Charlotte Department of Transportation

Memorandum

Subject: Rezoning Petition 14-084: Approximately 1.5 acres located on the north side of East 7th Street between Clement Avenue and Pecan Avenue

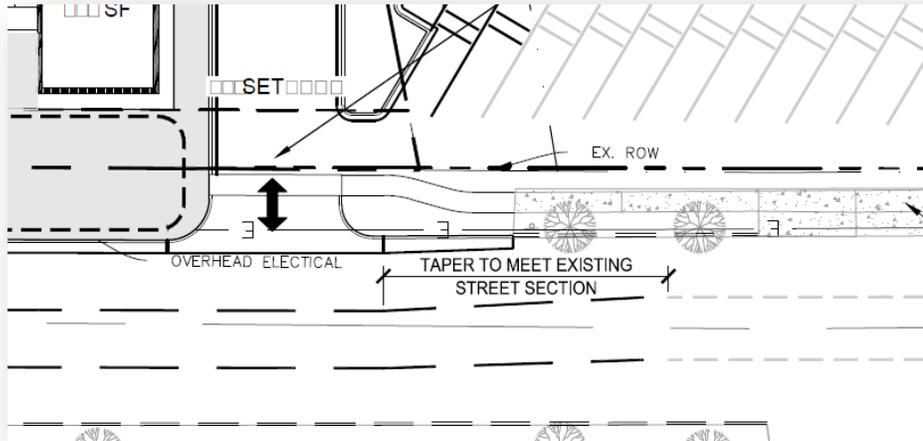
1. According to the Elizabeth Area Plan, curb lines on 7th Street are to remain in the existing location. The taper of the existing street section illustrated on the site plan below need to be removed and the proposed curb and gutter constructed in the existing curb location with no changes to the existing pavement.

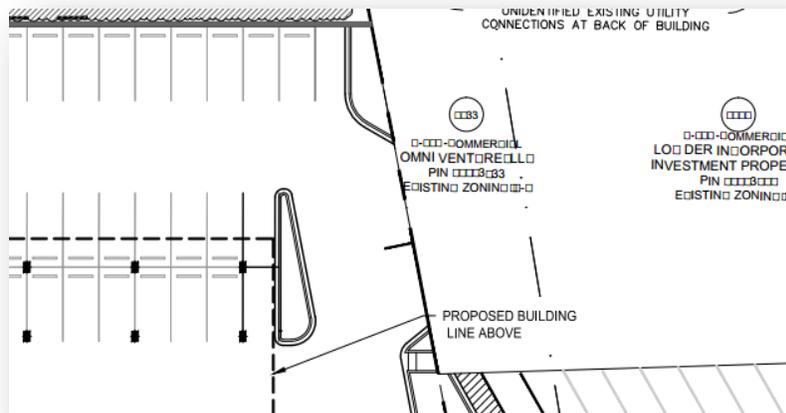
1. We request the petitioner remove the parallel parking adjacent to the existing building on parcel 12703133 (see below).
